Taunton Group

Glass Island View Subdivision Application SUBFY2020-6

Subject: Incorporating accuracy statistics when attempting to quantify cut & fill volumes based on LiDAR data.

**Existing Conditions -
Topographic Survey -
Project Area**

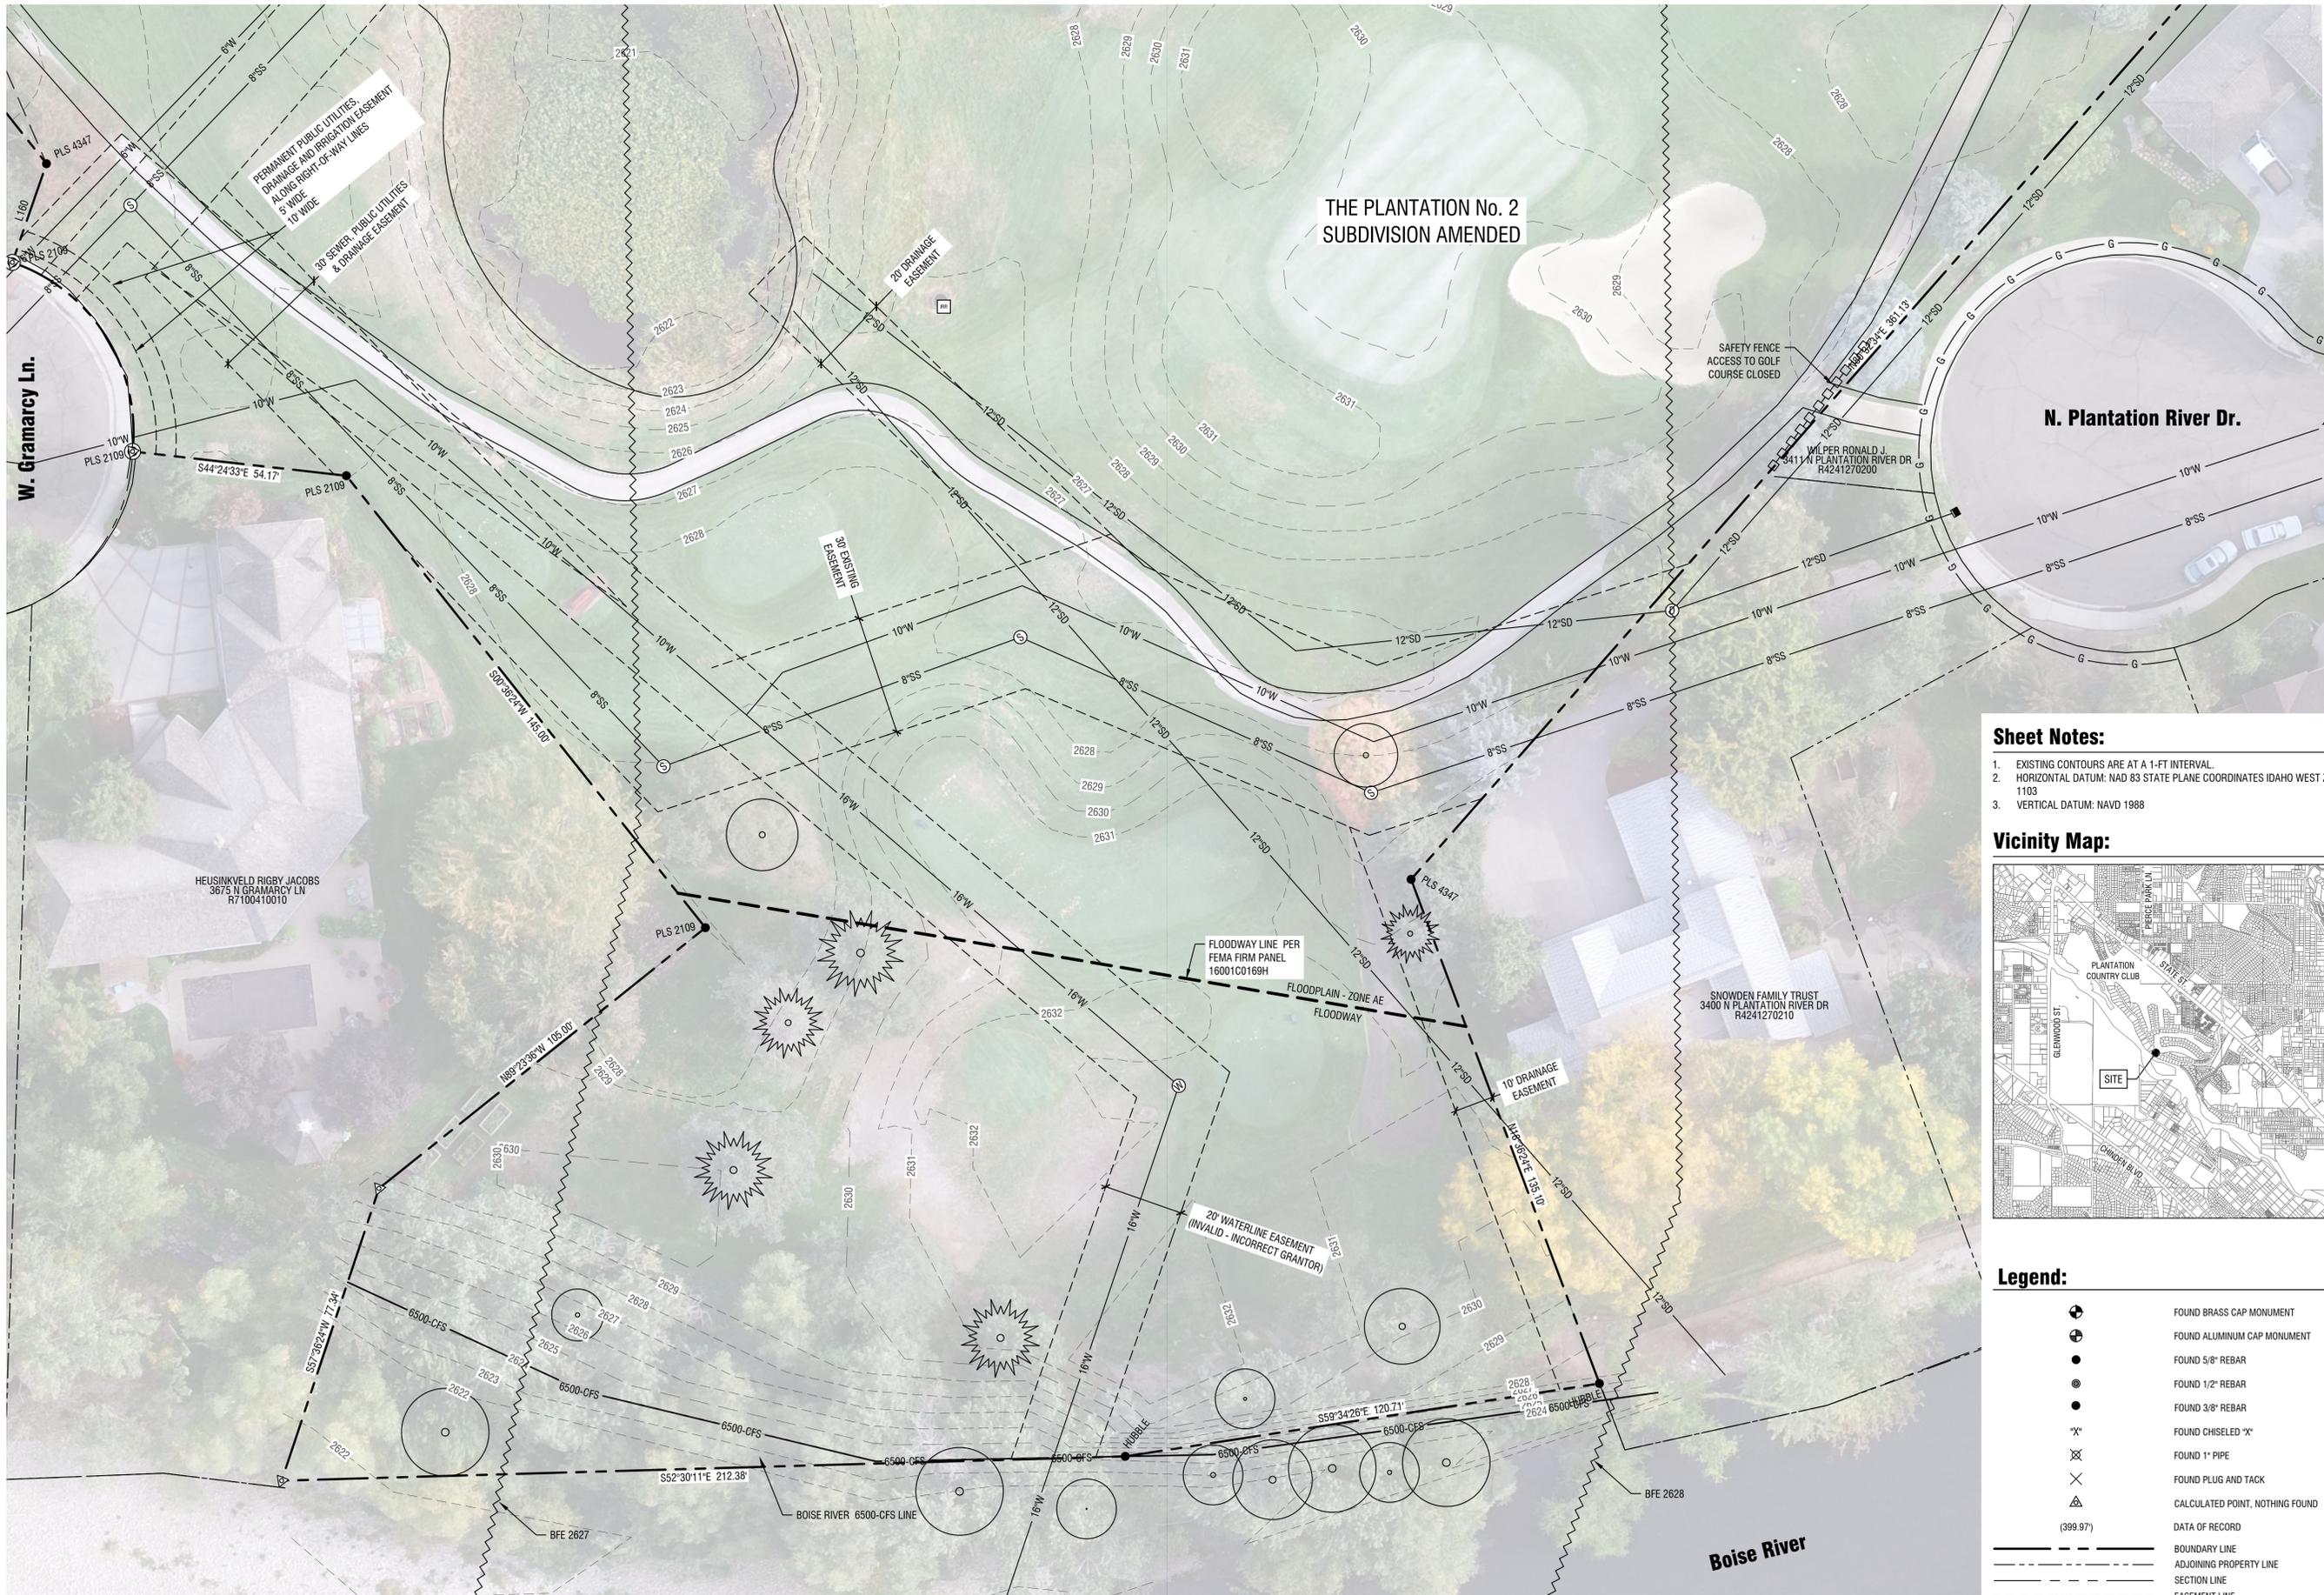
The vertical accuracy of the data sets must be taken into account when attempting to quantify fill. When we incorporate the RMSE of each data set into the comparison we create a range of volumes. We tried to match Quadrant’s area of comparison (figure below). Note that not all of the area is vegetated but a more precise analysis was not possible at the time. We can say the volume change over time lies somewhere between 1,100 cubic yards of cut and 2,550 cubic yards of net fill between 2007 and 2019.

Net Change (cu.yds)
Upper Limit Estimate	2,550 (Fill)
Unadjusted Estimate	790 (Fill)
Lower Limit Estimate	1,100 (Cut)
